A1 Birtley to Coal House

Applicant's Responses to ExA's Second Written Questions - Appendix 2.0E - Structure Options Report 11 - PCF Stage 3 - Allerdene Viaduct

**PCF Stage 3 – Allerdene Viaduct
Structure Option Report No.11**

Safety Engineering & Standards (SES) Record Sheet					
Scheme Name:	Birtley to Coal House Scheme – PCF Stage 3 – Allerdene Viaduct	<u>Comments Sheet Document Control</u>			
		Comment sheet version	Date HA comment sheet	Date Designer's reply sent	Notes
Document Ref	HE551462-WSP-SBR-S3-BR010-X-RP-CB-00001-P01.2	A	25/01/2019	22/03/19 Updated Response 28/03/19	
		B			
AIP version		C			
		D			
AIP Date	19 December 2018	E

INDICATIVE TYPICAL WEATHERING STEEL GIRDER AT SECTION A-A
SCALE 1:20

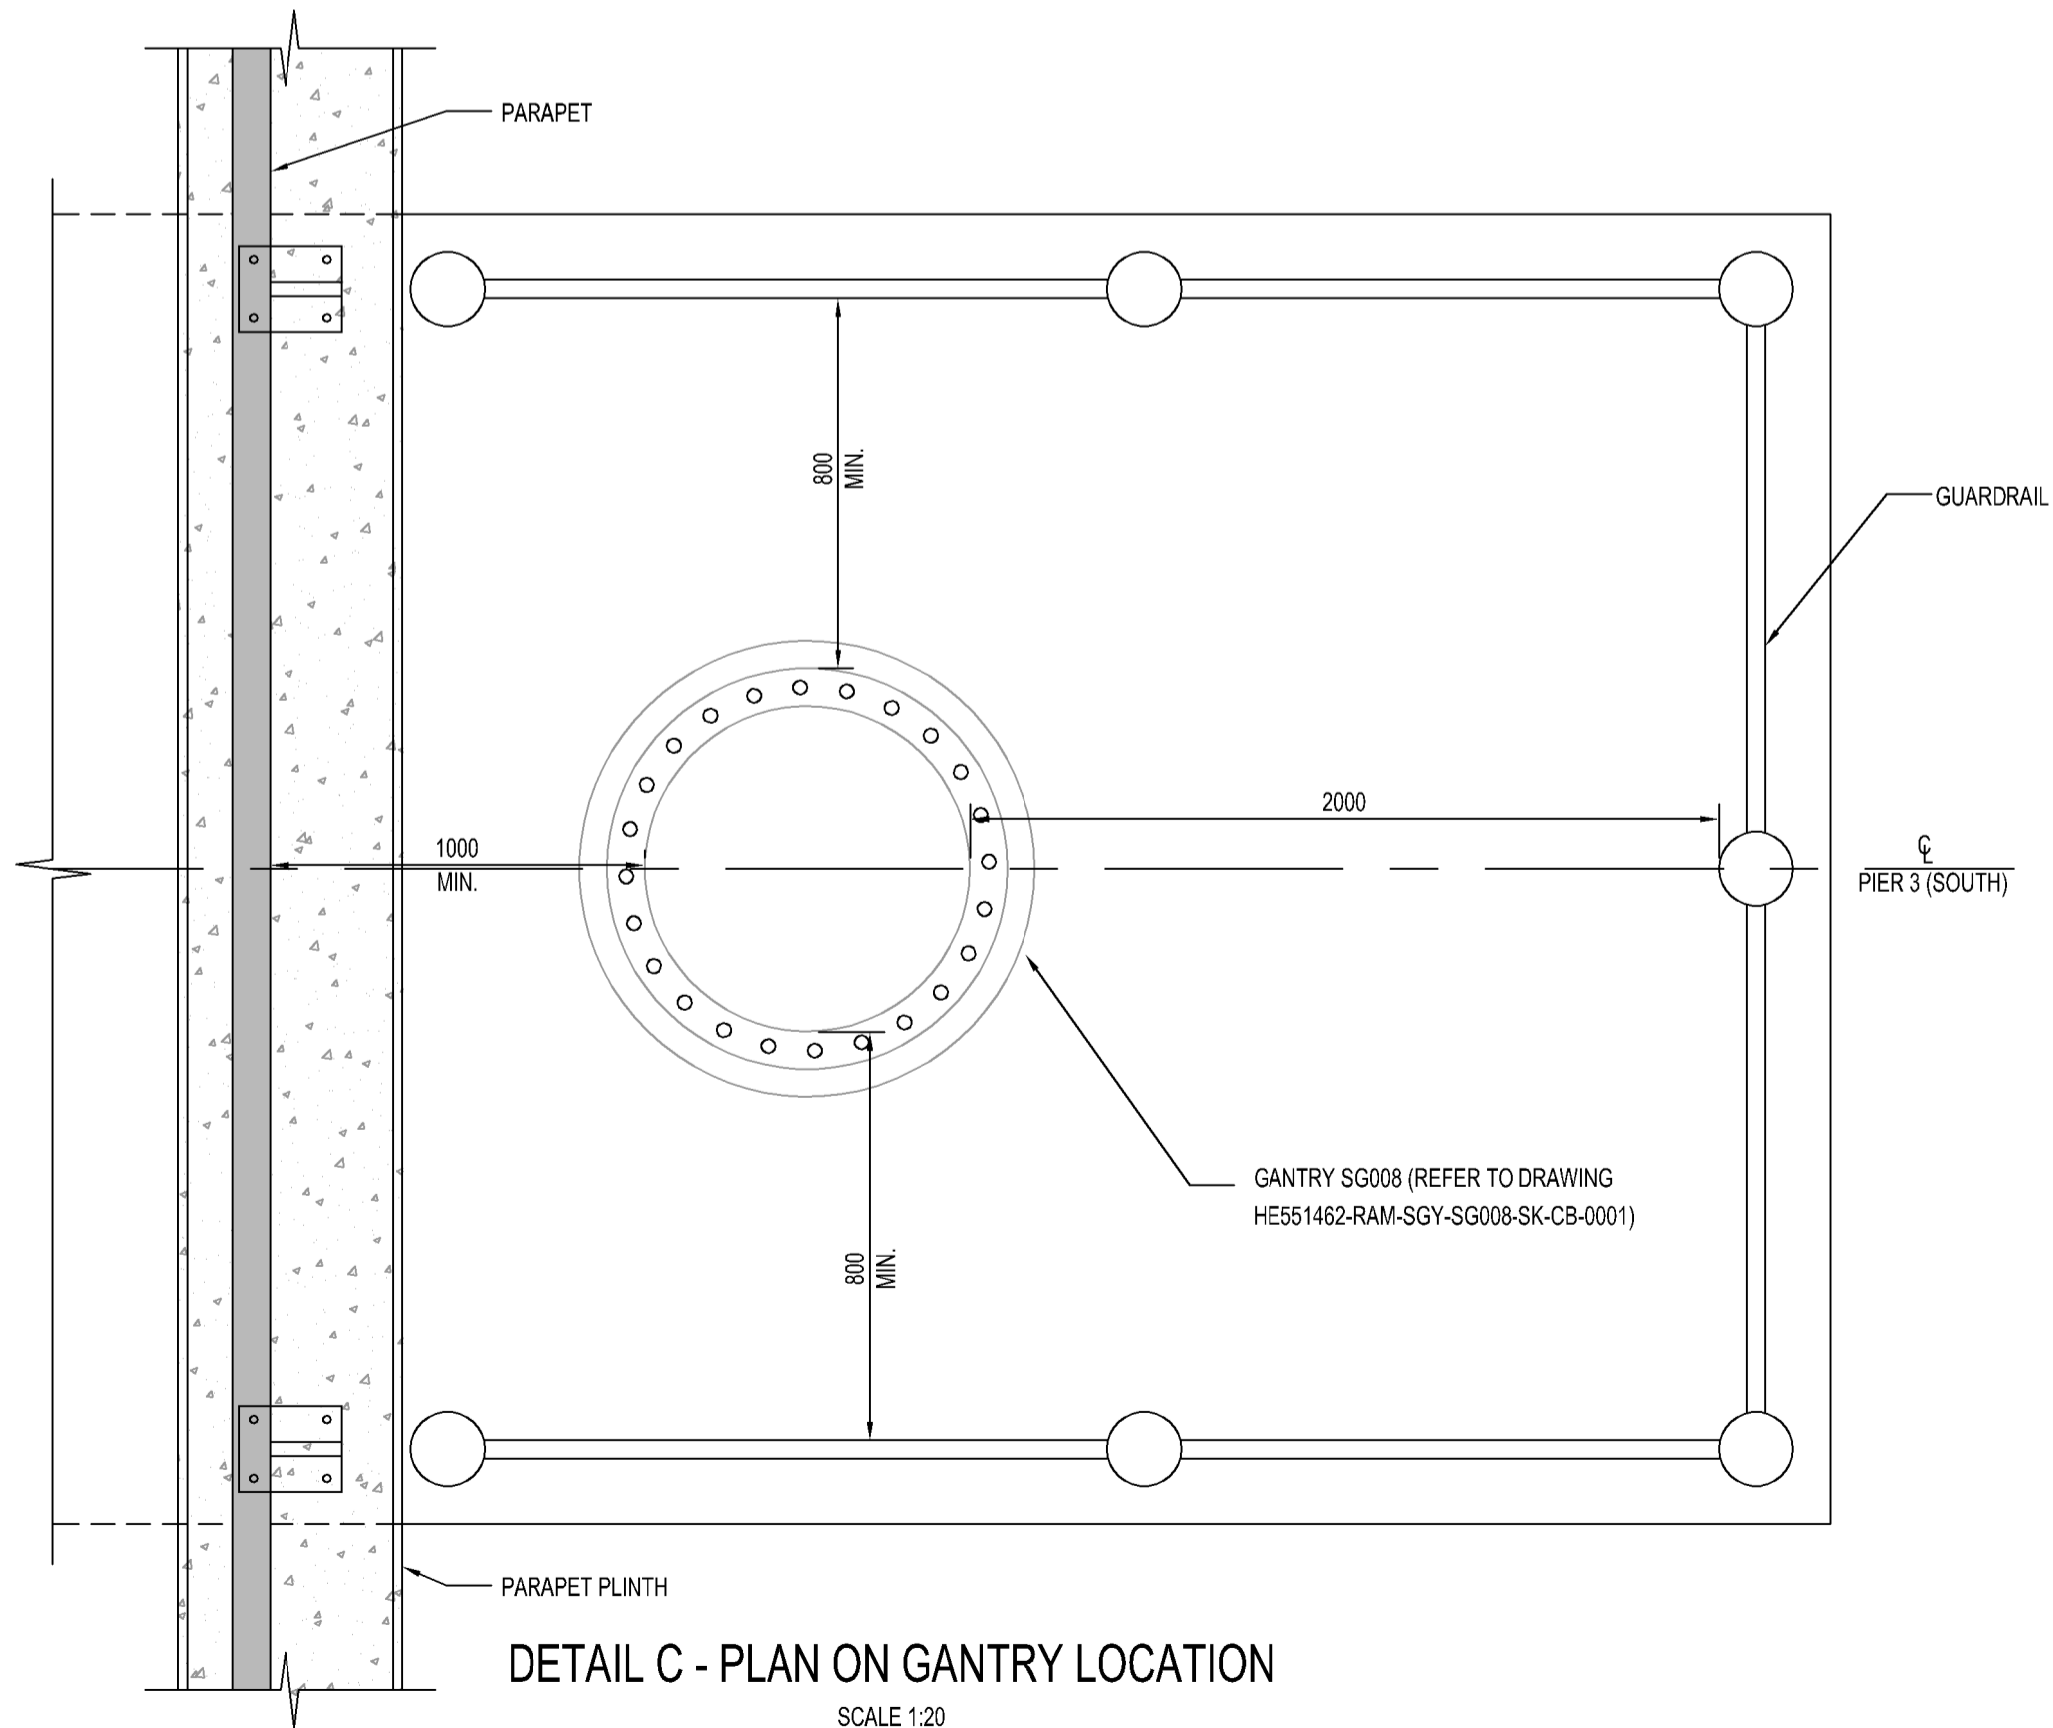
55	Appendix E – drawing 103	<p>Please show anticipated splice position.</p> <p>The parapet over railway does not look like 1.8m h4A solid infill parapet.</p>	<p>Noted, this is an outline general arrangement drawing. Comments shall be communicated to the detailed design delivery partner and addressed at detailed design should the viaduct be the preferred option.</p> <p>27/03/19 No change required to dwg at this stage</p>	
56	Appendix E – drawing 105	<p>Should there not be transverse stiffeners at jacking point locations? Please shown F6 finish to piers.</p>	<p>Noted, this is an outline general arrangement drawing. Comments shall be communicated to the detailed design delivery partner and addressed at detailed design should the viaduct be the preferred option.</p> <p>27/03/19 No change required to dwg at this stage</p>
